RE: Comments on Public-Noticed Draft 401 Certification (NPDES Permit No. ID00000175) for Hecla Limited Lucky Friday Mine

RE: Comments on Public-Noticed Draft 401 Certification for the Draft Permit (No. ID00000175) for Hecla Limited Lucky Friday Mine

RE: Comments on Public-Noticed Draft NPDES Permit (No. ID00000175) for Hecla Limited Lucky Friday Mine

Figure 1. Stream Flow and Hardness Relationship

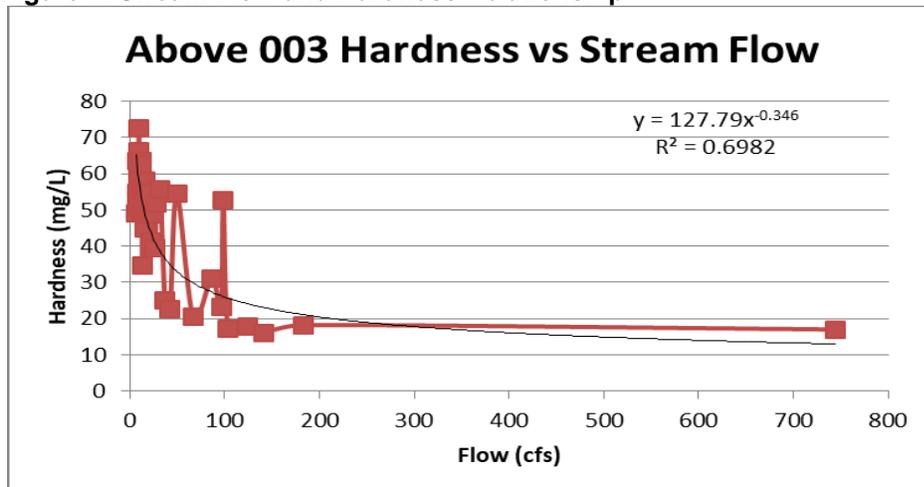
Comment #34, Appendix C.Part A(Page 69): As per the draft Fact Sheet, receiving stream hardness occurring at low flow conditions (i.e, 1Q10, 7Q10) was estimated based by plotting flow versus hardness data, collected upstream of Outfall 002 and 003 and is shown in Figures C-1 and C-2 of the Fact Sheet. As discussed in the *Idaho Mixing Zone Implementation Guidance*, use of such method is acceptable for estimating hardness at low flow for hardness-based metals criteria calculations. However, the statistical relation between hardness and flow should be determined by a nonlinear regression, as noted in the Guidance. While for Figure C-1 (Upstream of Outfall 002), low flow hardness was estimated from a regression using a polynominal trend line, a linear regression was used for Figure C-2, which was used to estimate the hardness of 49.8 mg/L at the 1Q10 and 49.7 mg/L at the 7Q10, for upstream of Outfall 003. The R² value for this linear regression is only 0.2897, which indicate low relationship between the trend line and actual data. LFU suggests that for estimating low flow hardness upstream of 003, a non-linear regression should be used. Using upstream hardness and corresponding river flows for Outfall 003, Figure 1 below presents a more appropriate analysis of the relationship. Using a power regression type provides for a much higher R² value, indicating a more realistic estimate of hardness at low flow. Using the information in Figure 1 below results in estimated low flow hardness of 81 mg/L at the 1Q10 flow of 3.7 cfs and 72 mg/L at the 7Q10 of 10.9 cfs (low flows as per Fact Sheet). Therefore, LFU requests the Figure C-2 be revised to utilize the more appropriate regression type and resulting estimated hardness.
